**Ballot ID:**

**Title:** Maximum Acceptable Safety Risk Target Calculation

Committee Draft

## Part 1—Inspection Planning Methodology

**Figure 4.2—Unbalanced Risk Matrix Example**

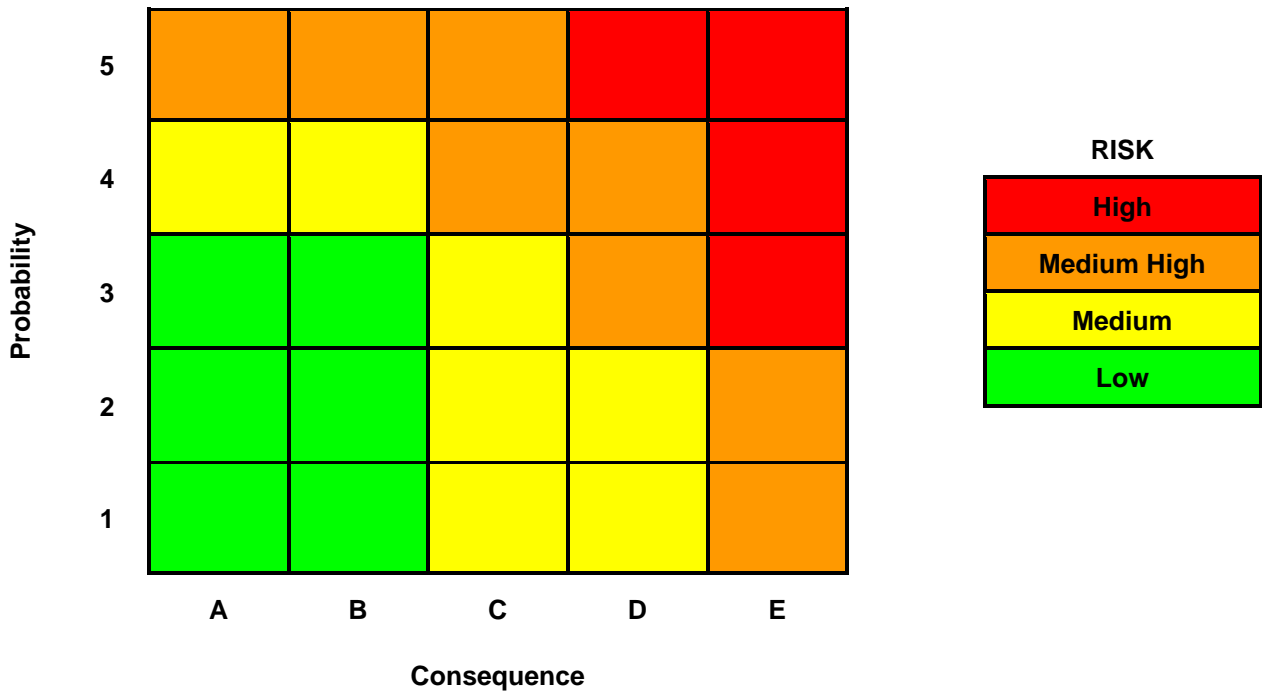
Two risk matrix examples are shown in Figure 4.2 and Figure 4.3. In both figures, POF is expressed in terms of the number of failures over time,  $P_f(t)$ , or DF. COF is expressed in area or financial, or injury terms. Example numerical values associated with POF and COF (as area, or financial, or safety) categories are shown in Table 4.1 and Table 4.2. The matrices do not need to be square (i.e. 4x5 risk matrix, 7x5 risk matrix, etc.).

- a) Unbalanced Risk Matrix (Figure 4.2)—POF and COF value ranges are assigned numerical and lettered categories, respectively, increasing in order of magnitude. Risk categories (i.e. Low, Medium, Medium High, and High) are assigned to the boxes with the risk category shading asymmetrical. For example, using Table 4.1 values, a POF of 5.00E-04 is assigned a Category 3 and a COF of 800 ft<sup>2</sup> corresponds to a Category B. The 3B box is Low risk category when plotted on Figure 4.2.

Figure 4.6—Example Iso-risk Plot for Injury Consequence

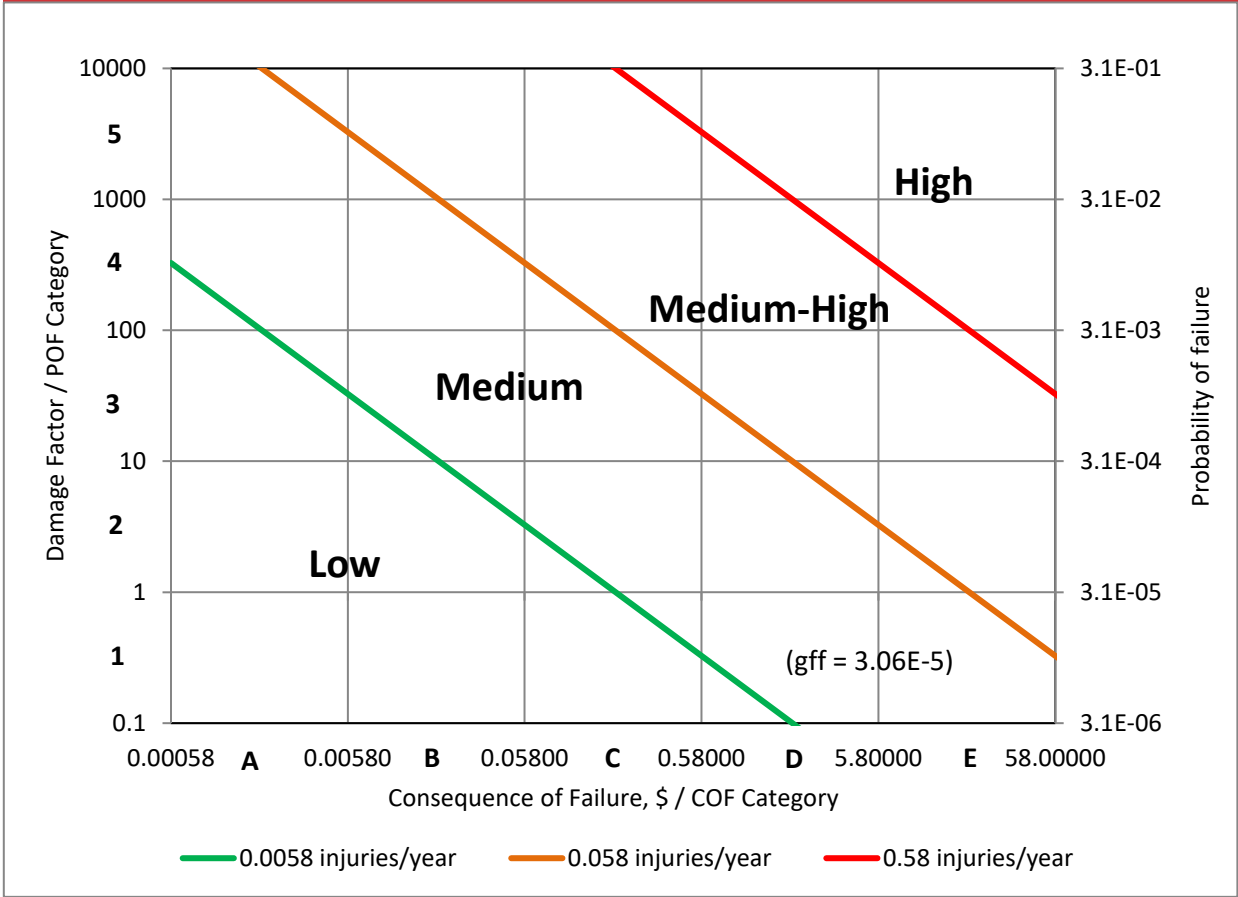
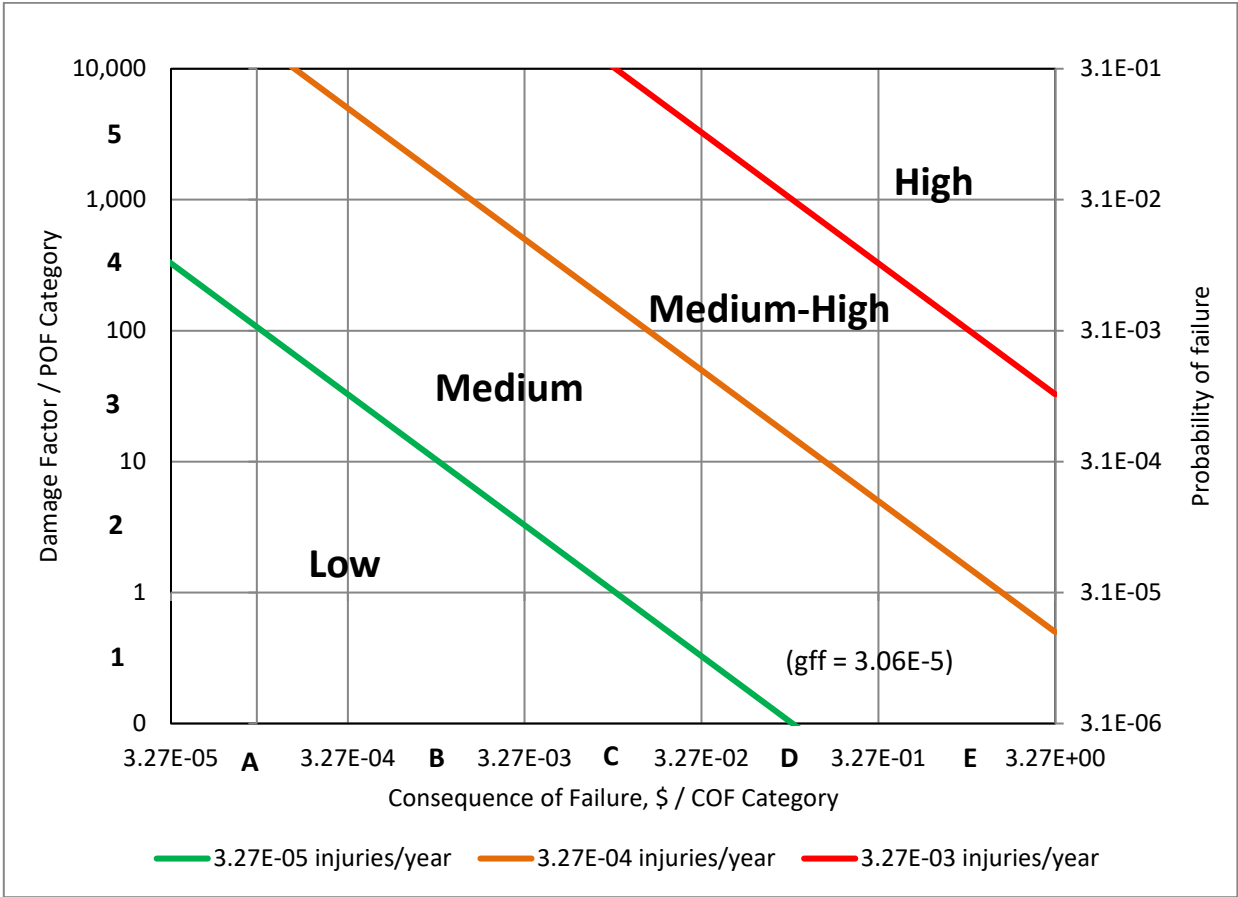
As in a risk matrix, POF is expressed in failures over time,  $P_f(t)$ , or DF while COF is expressed in area ~~or~~ financial, or safety terms. Risk categories (i.e. Low, Medium, Medium High, and High) are assigned to the areas between the iso-risk lines and dependent upon the level of risk assigned as a threshold between risk categories, as shown in Figure 4.4. For example, a POF of 5.00E-04 and a COF of \$125,000 are assigned a Medium risk category.
